Project AC-NH-060-BC 002)  
H513701C  
Grand Avenue (US-60)  
27<sup>TH</sup> avenue/Thomas Road

## **Final Environmental Assessment**

### **GRAND AVENUE (US 60) 27<sup>TH</sup> AVENUE/THOMAS ROAD**

### **III. ERRATA FROM THE DRAFT ENVIRONMENTAL ASSESSMENT**

**Figure 11. Alternative 8: Grand Avenue Overpass** (DEA page 16.)

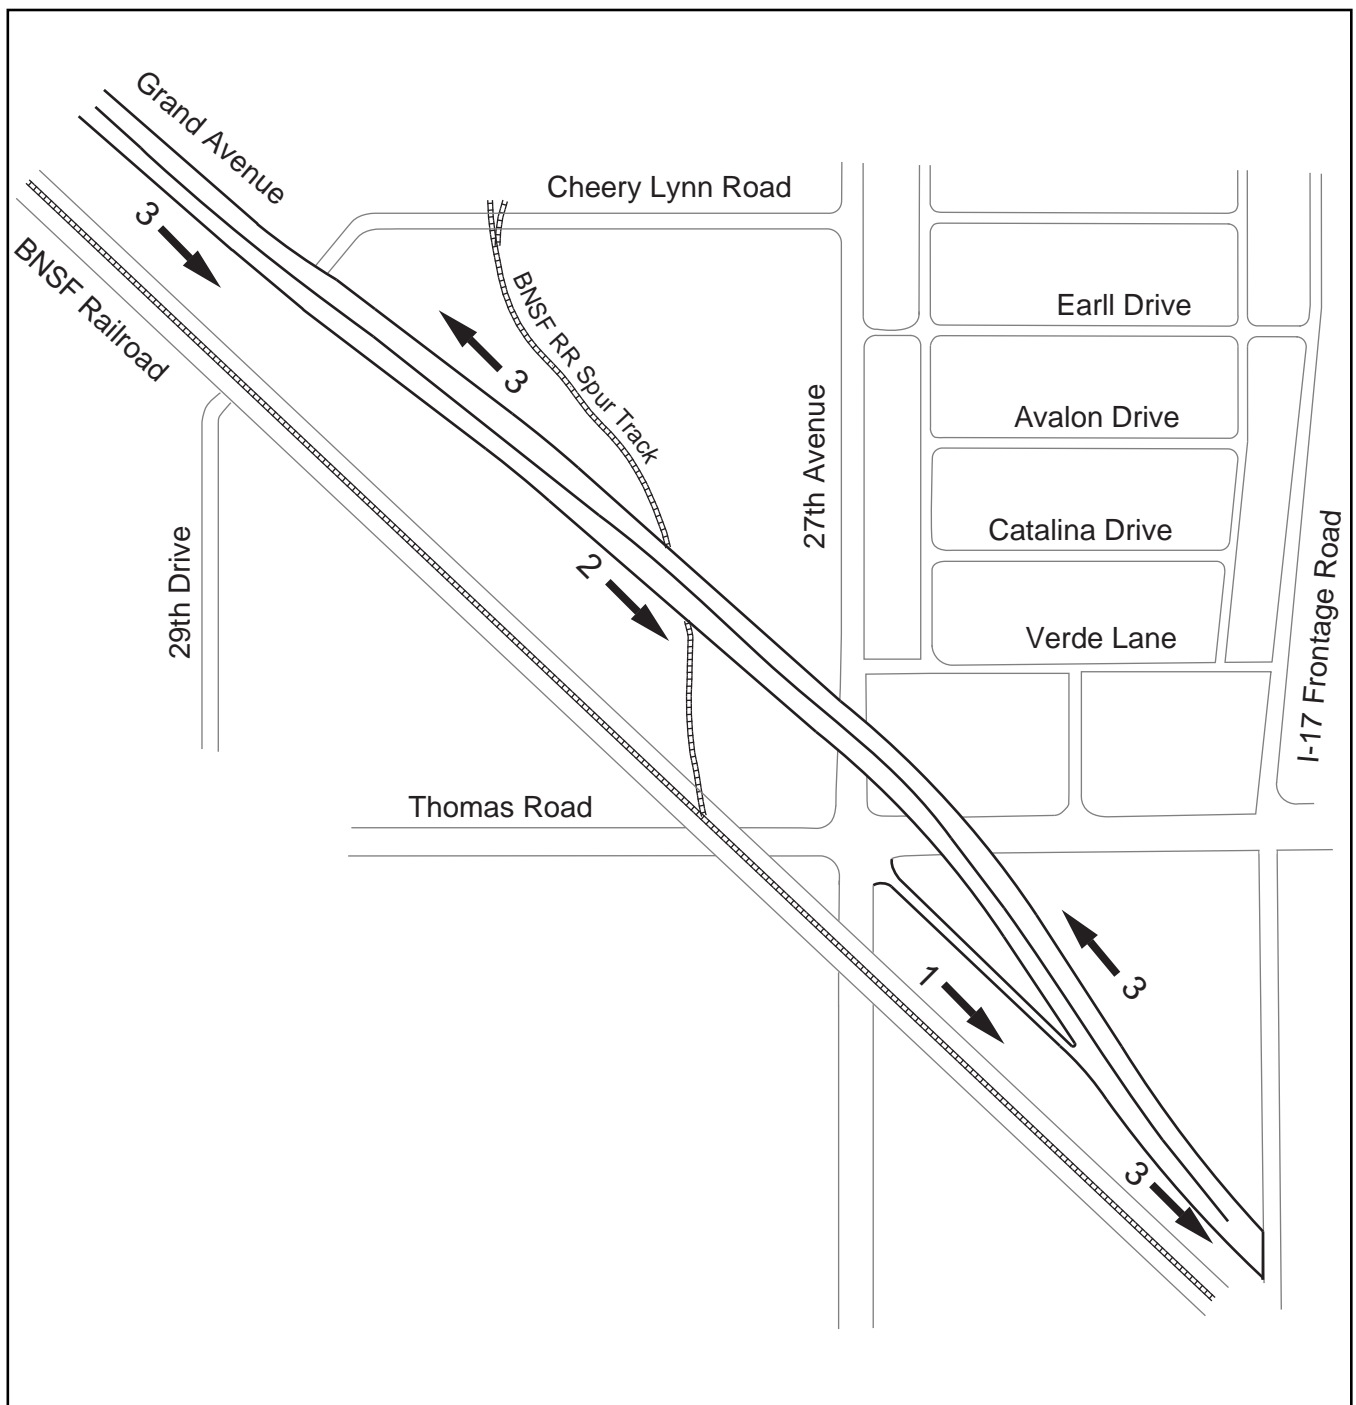
Verde Lane has been revised to be open west of 26<sup>th</sup> Drive. In addition, the right-of-way line from the alley directly south of the residences has been revised to include a full take of four residences. (Refer to page 13 of this document.)

**Figures 5, 6, 7, 8, 9, and 10** (DEA pages 7, 9, 11, and 13.)

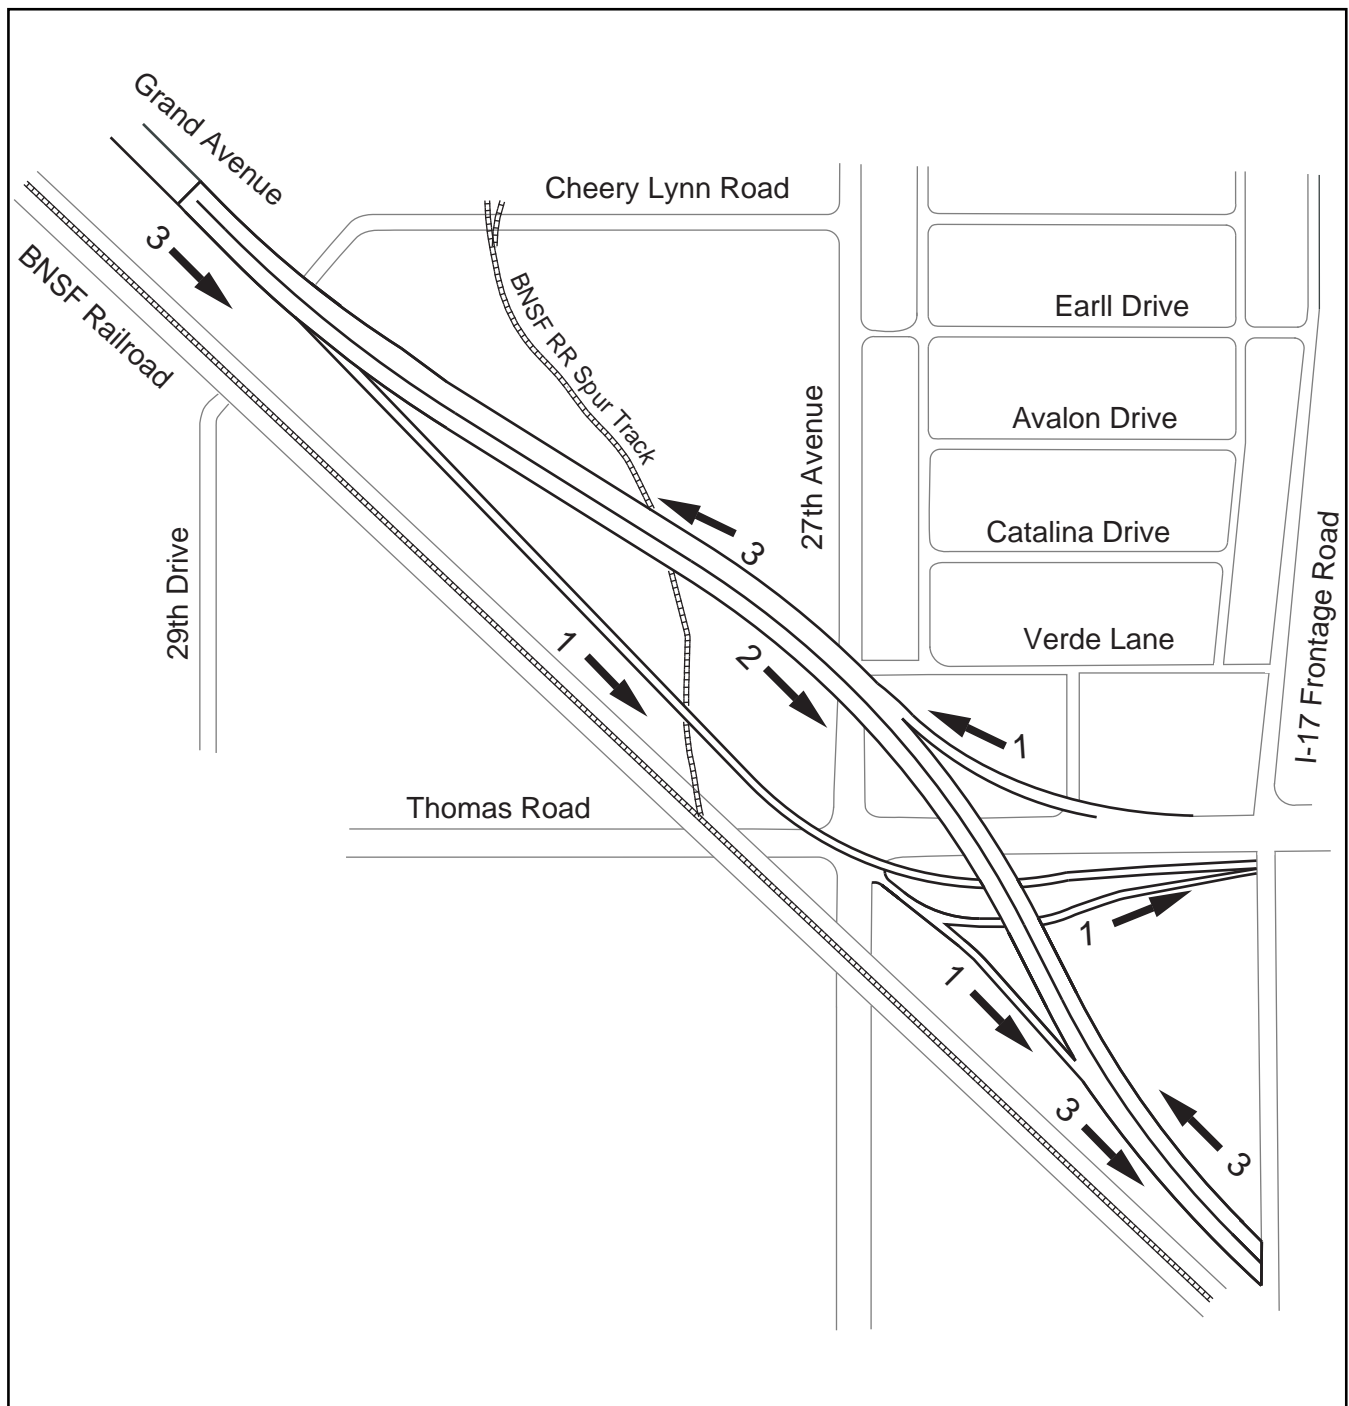
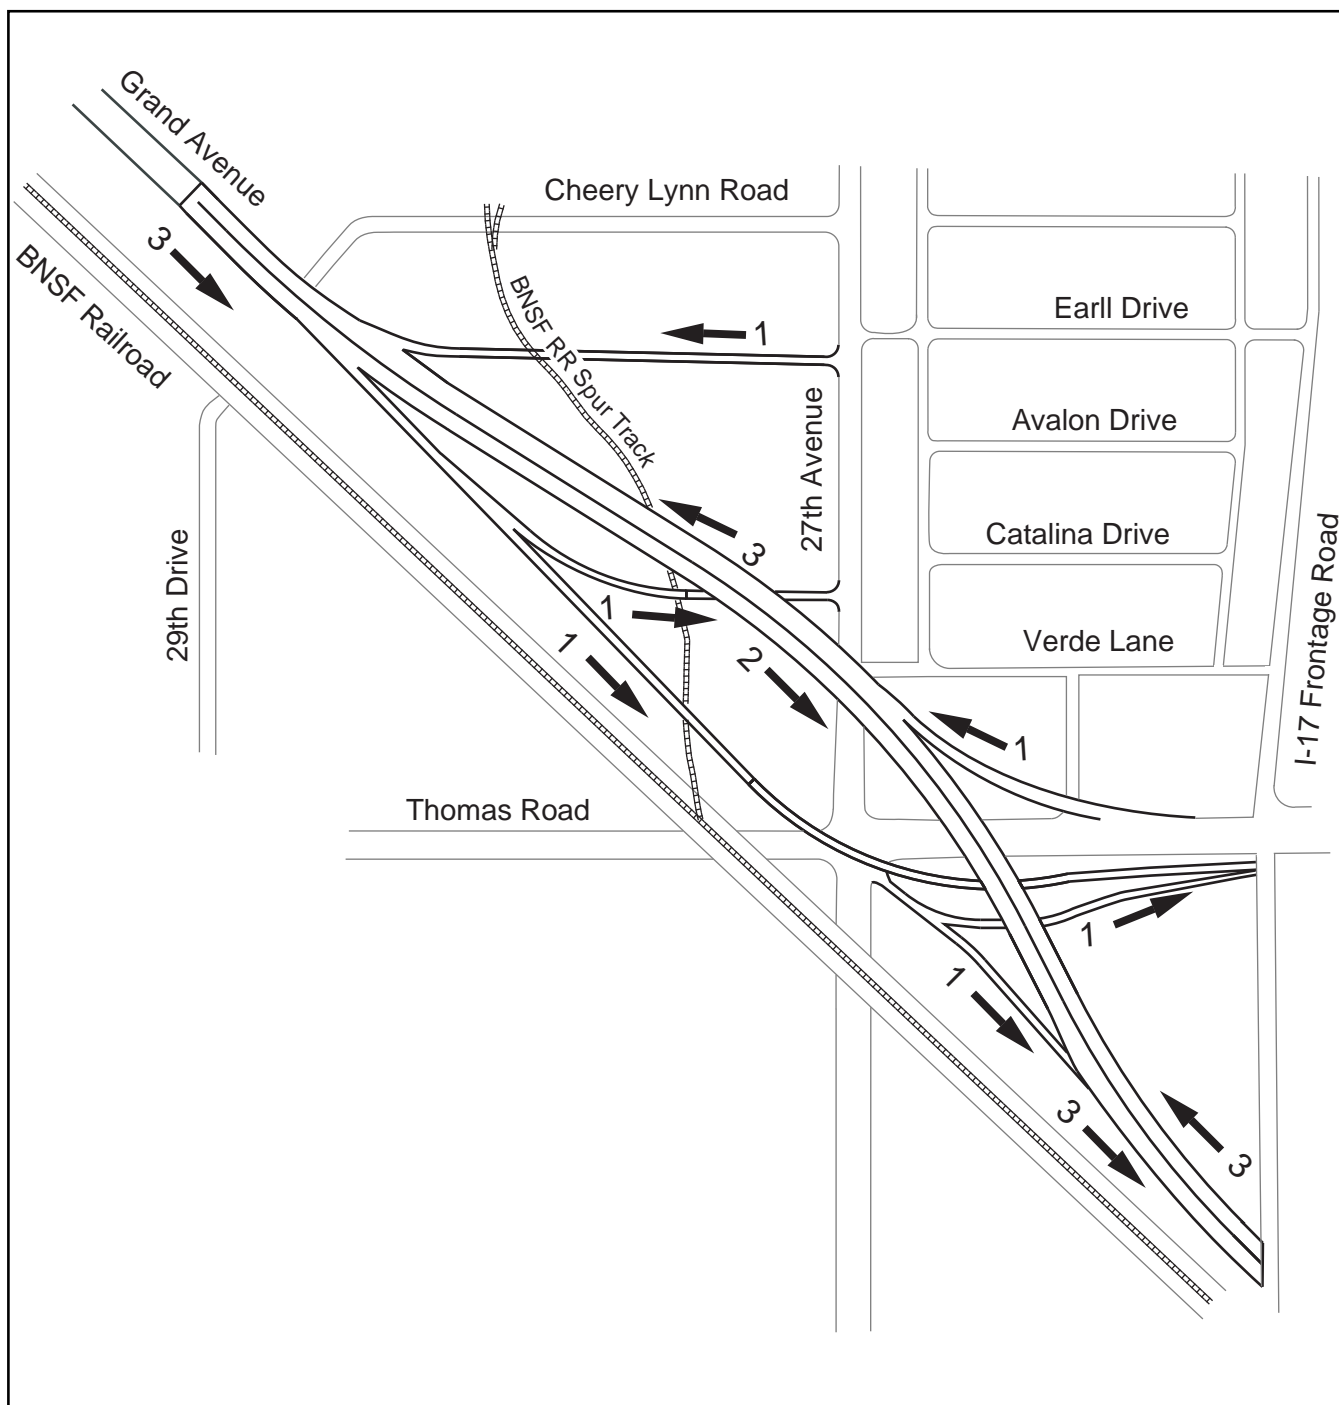
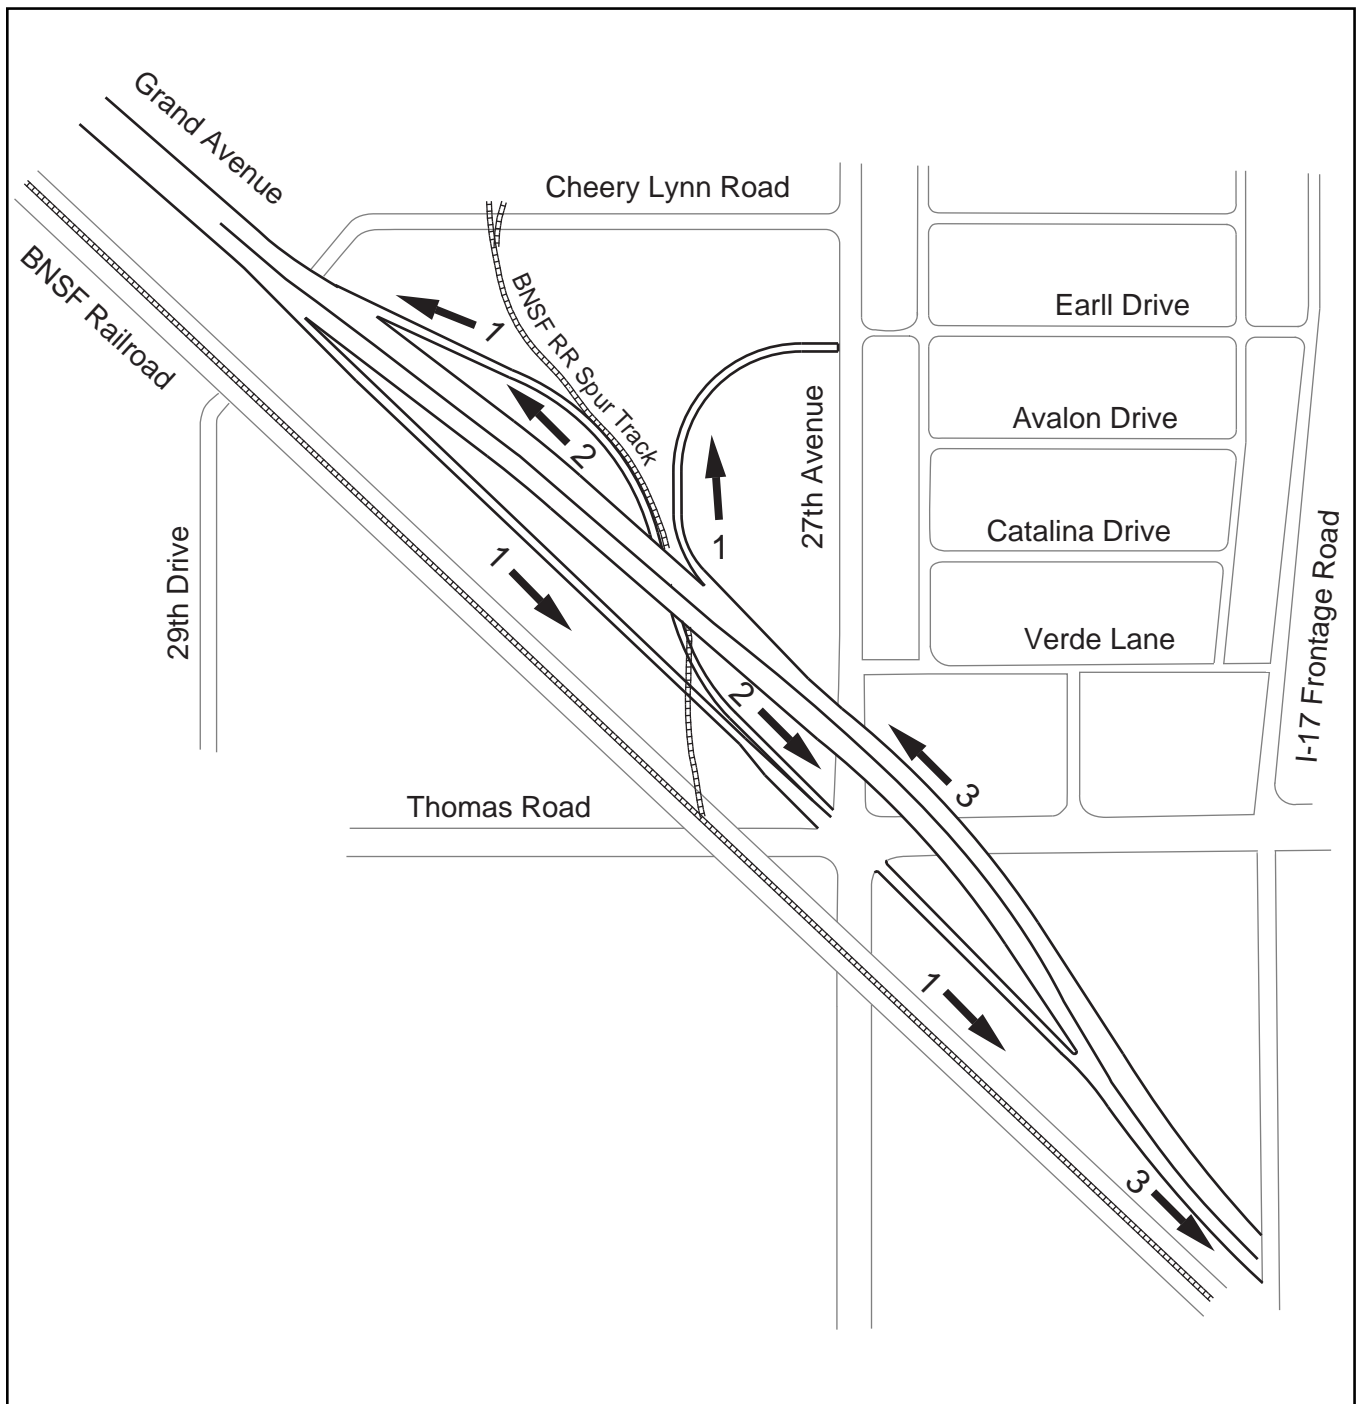
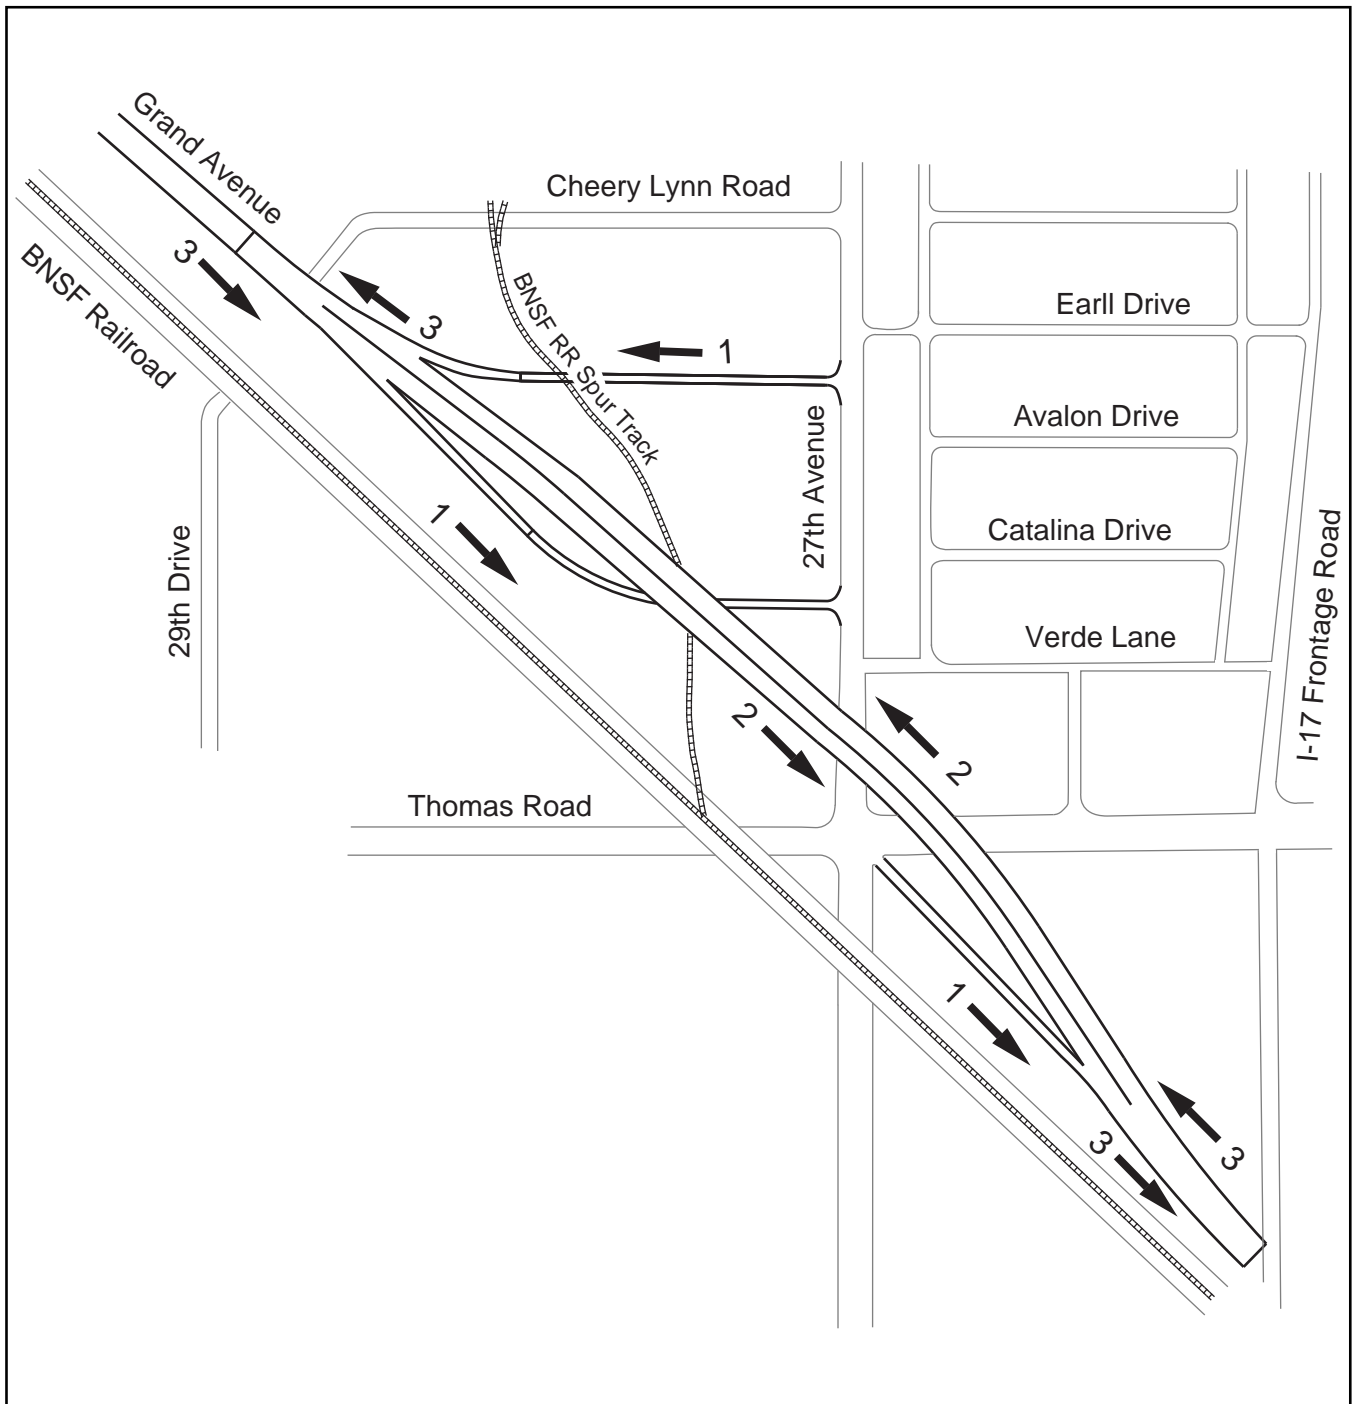
Verde Lane west of 26<sup>th</sup> Avenue has been revised to connect to the Interstate 17 (I-17) frontage road. (Refer to pages 7-12 of this document.)
